Engineers Comments Regarding Surface Water Drainage

Application Reference:	F/16/24/RES	Reviewer Reference:	ADC/SB
Planning Officer:	Jessica Riches	Date of Review:	06/01/2025
Site Name:	Land at Ford Airfield Ford		
Application Description:	Approval of reserved matters following outline permission F/4/20/OUT for phase reserved matters 4 (south), for the erection of 357 No. residential dwellings plus associated roads, infrastructure, parking, landscaping, open space & play areas and associated works. This application affects a Public Right of Way, may affect the setting of a Listed Building and falls within CIL Zone 1 (Ford strategic site - zero rated).		
Assessment Number:	1 of 1

Figure 1: Northern section of the parcel shown as draining to the road on Drainage Layout 1.

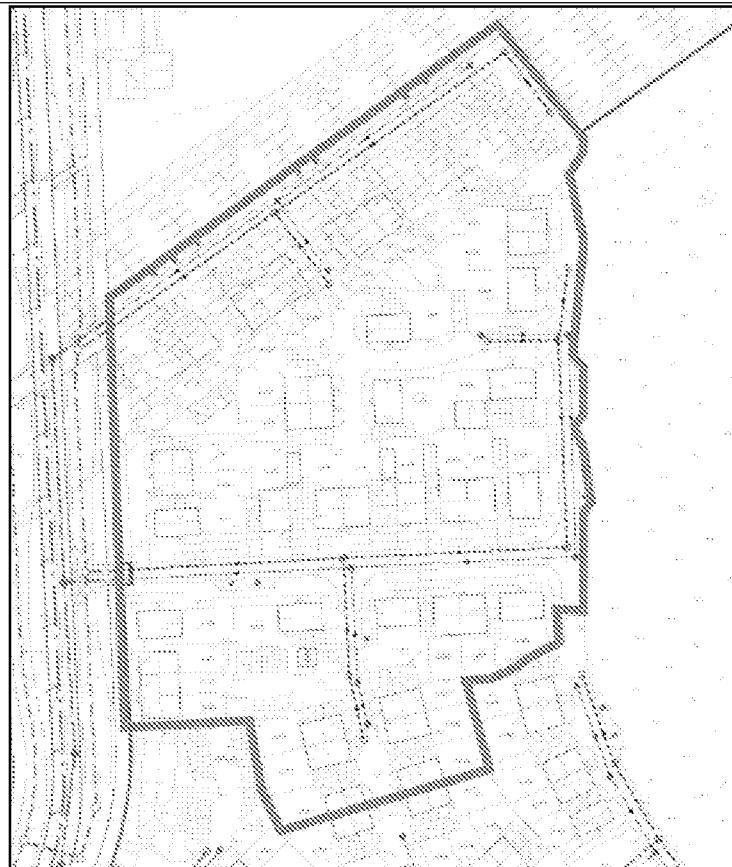
On Drainage Layout 1 a northern part of this parcel is shown as flowing to the road on the layout – this is illustrated and bordered with green on figure 1 below. The road ultimately discharges to basin 3, which outfalls to Watercourse 1. This area does not appear to naturally drain in this direction, the topography of the site indicates that surface water is likely to flow south and southwest. By diverting surface water to a different outfall, volumes and rates may be artificially increased which may increase flood risk downstream.

Figure 2: Northern section of the parcel shown as draining to Drainage Area 5 on ISW Plan.

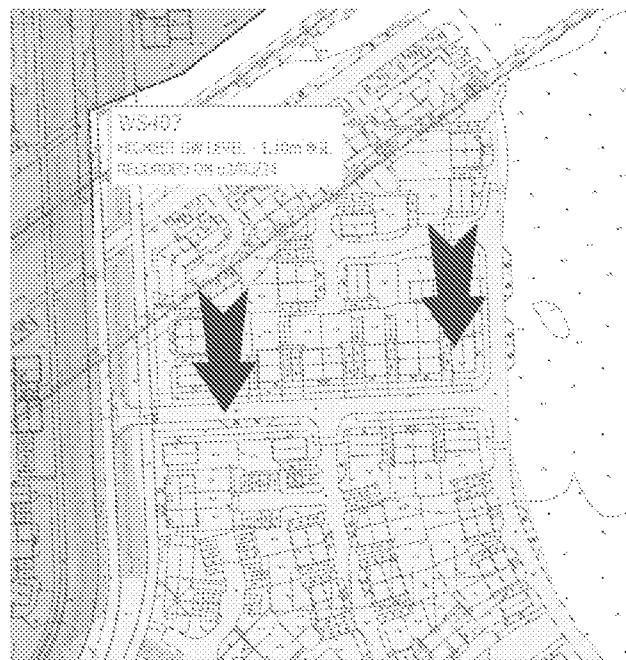
On the ISW plan this area discharges to the southern basins with the remainder of the parcel which directly contradicts the drainage layouts.

Drainage Area 5 appears to have two different outfalls: Watercourse 1 and Watercourse 2 (via Drainage Area 6). By including basin 3 and the outfall Watercourse 1 within Drainage Area 5, it is difficult to assess the different drainage catchments accurately.

Figure 3: Phase 5 section which is likely to naturally drain to Drainage Area 5.

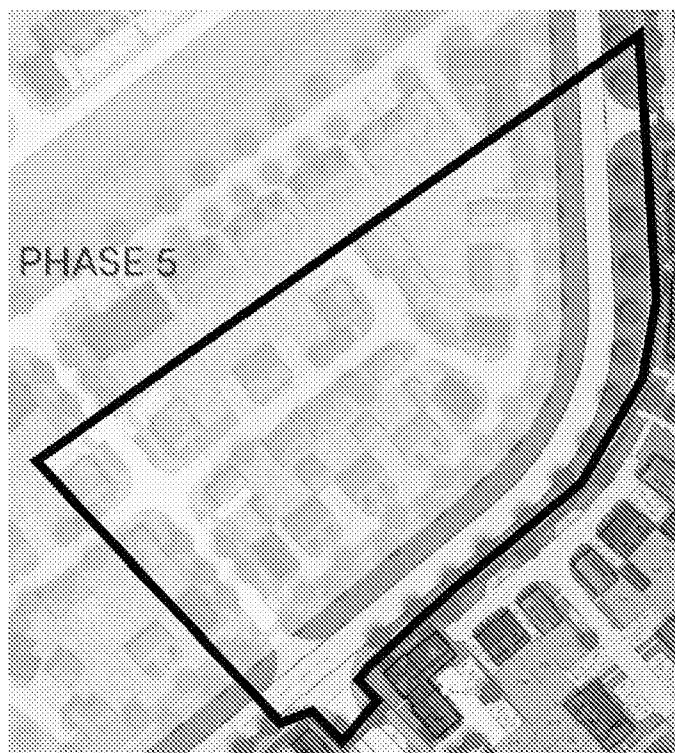
The topography of the site also indicates that part of the proposed Phase 5 housing should contribute to the same catchment as the northern half of this parcel. This area is south of the runway, and north of the public footpath as shown bordered in black in Figure 3. This is not shown on Indicative SW Strategy, which indicates that the full phase will discharge to network 1 (Drainage Area 3) and ultimately Watercourse 1. By discharging this area to that location, when it would naturally drain elsewhere, flood risk may be increased downstream.

Ford Airfield Watercourse Mapping and SW Flood Risk

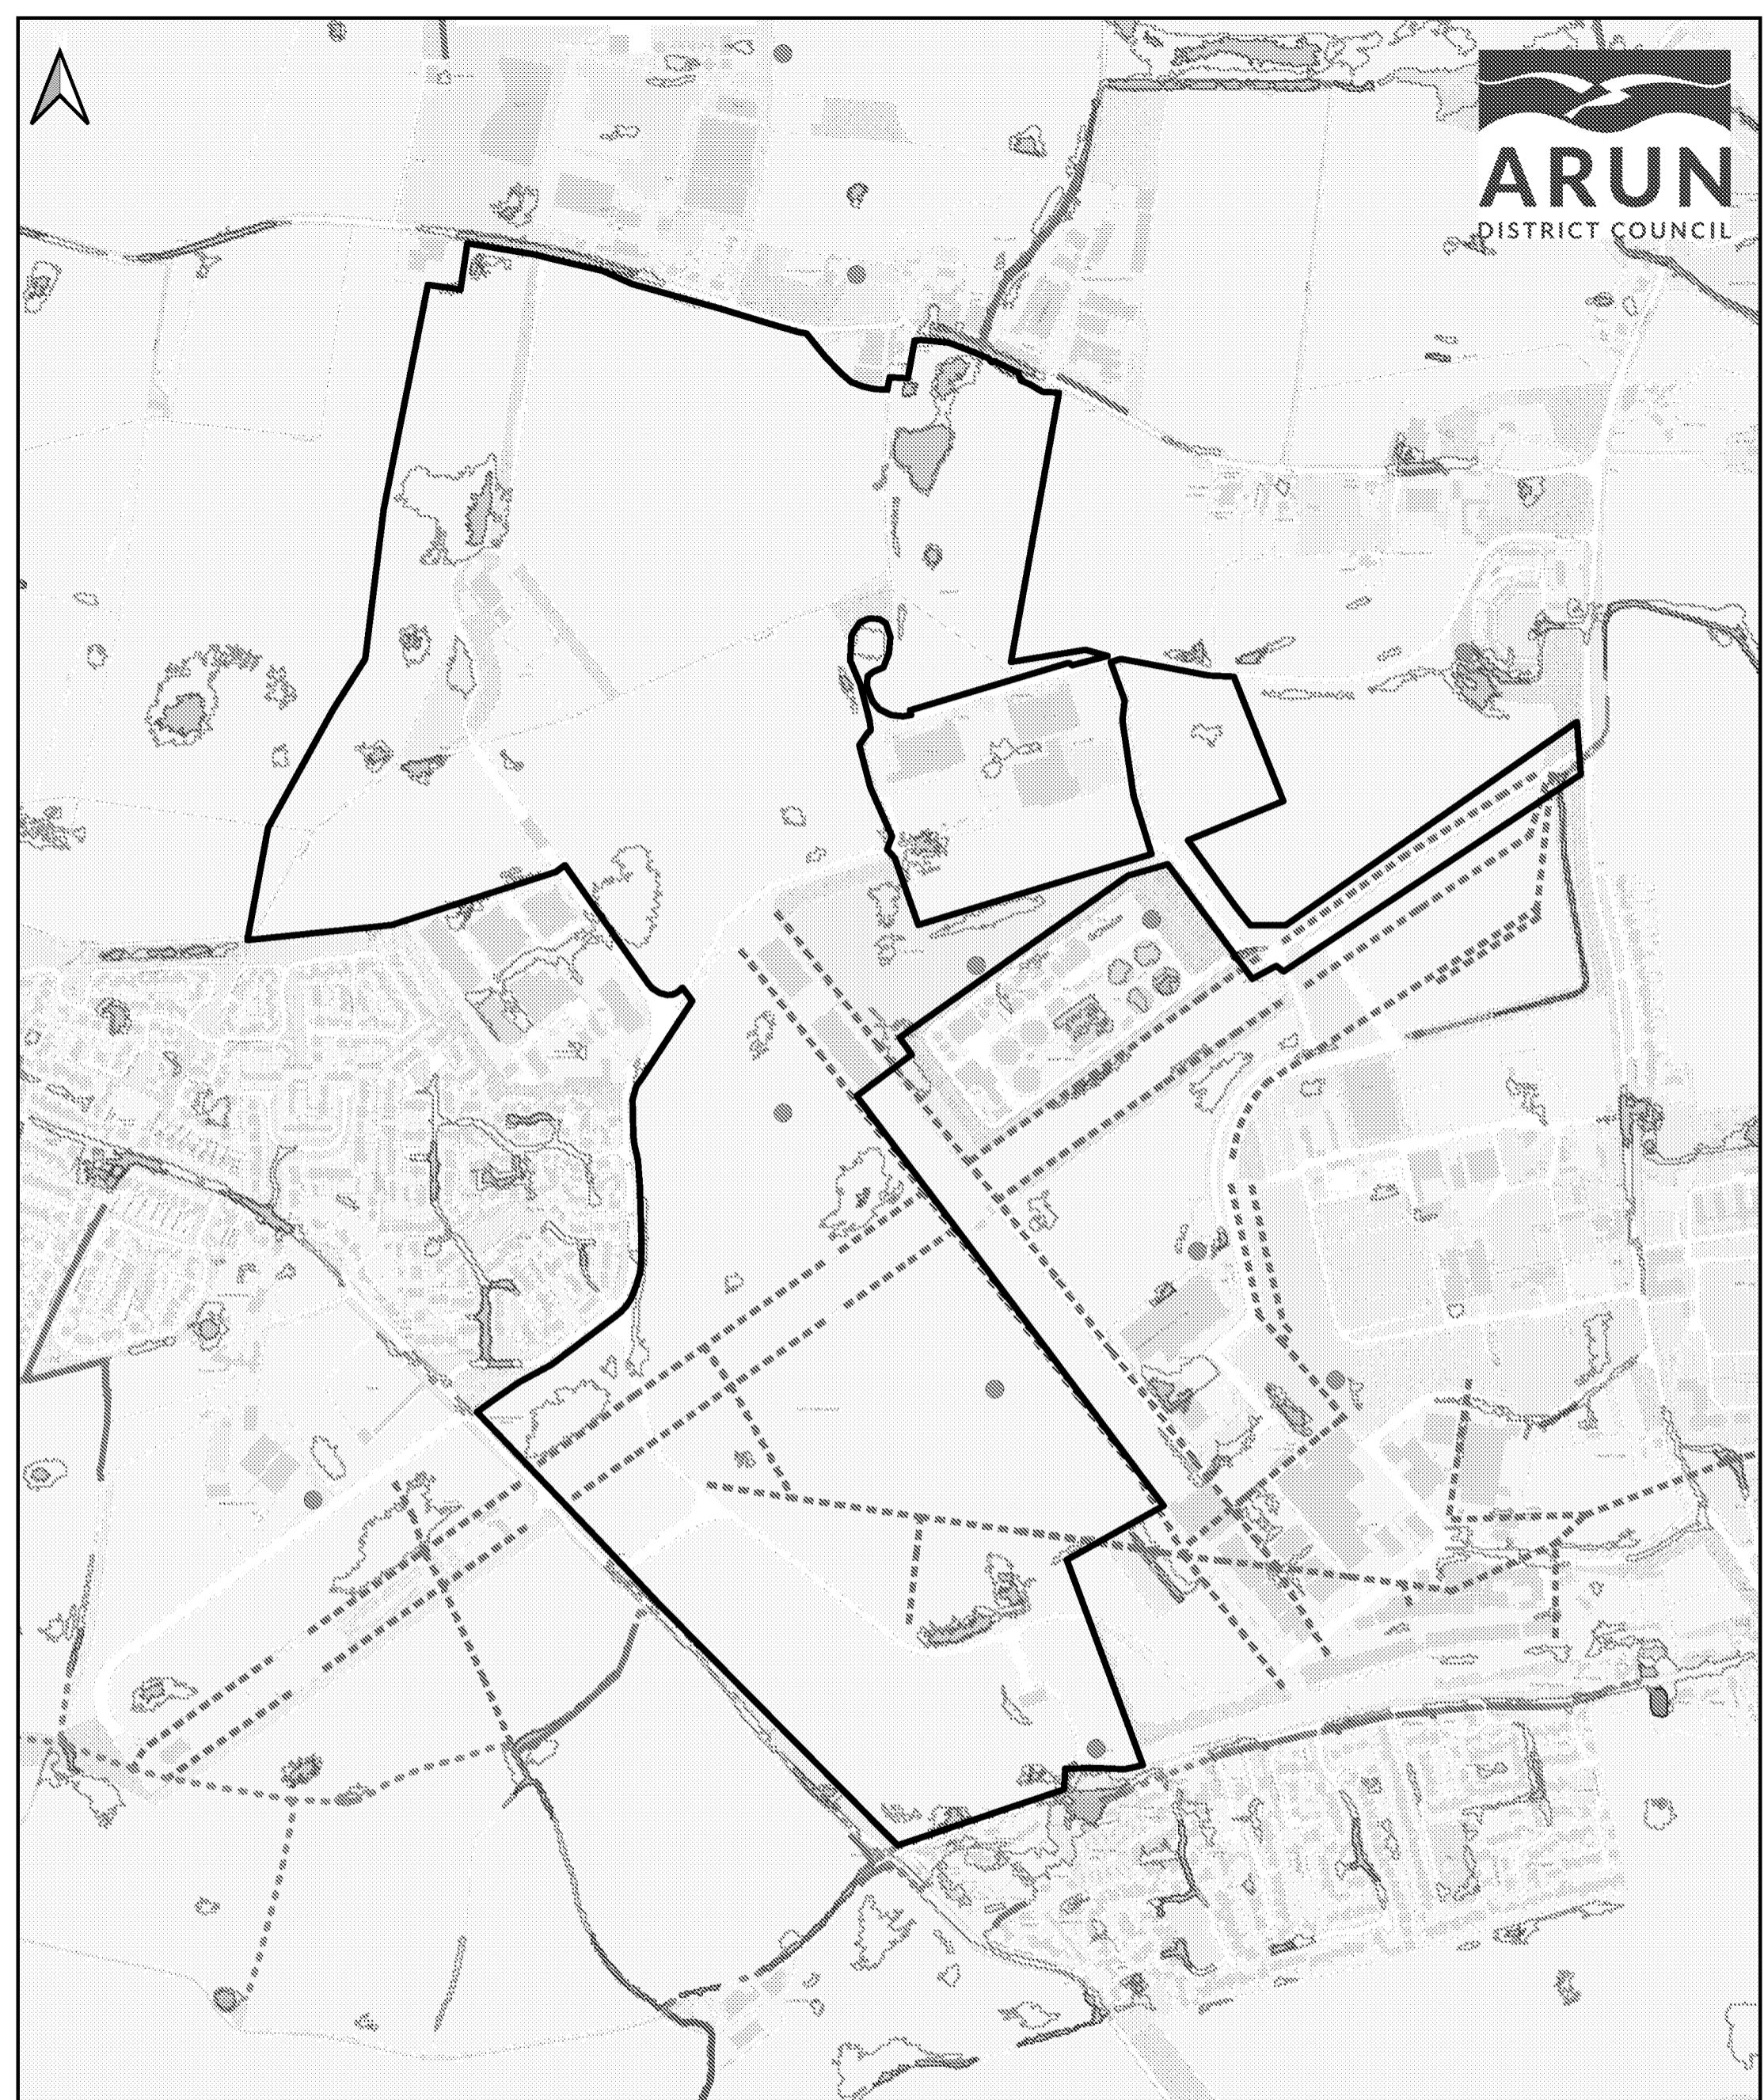
There is existing drainage infrastructure on the site installed to serve Ford Airfield. This is shown on the attached mapping. The mapping may not be accurate and needs verification, however, there is no doubt that the network exists.

The drainage system is not mentioned in the technical note. The existing drainage network for this part of the site discharges to the River Arun. At the point where the network outfalls, the river is a tidal waterbody and therefore less sensitive to the effects of surface water discharge.

Further investigation is required into the existing network. It is unclear where the collection points for these pipes are. If all these pipes can, or were once able to, collect surface water then most of the area north of the public footpath would discharge to the River Arun. By discharging all this area to the proposed discharge point for network 2, to Watercourse 2, opposite Horsemere Green Lane, flood risk may be increased.

Irrespective of whether the airfield drainage can and should be used, it is not acknowledged or protected. The ExAF Network is not shown on any of the site plans and nor has it been considered a constraint to the development of the layout of the site. The status and condition of the network is unknown, and it is unclear whether the network has a legal right to protection via our Land Drainage Byelaws. An easement of 3m either side of the edge of the culverts may be necessary.
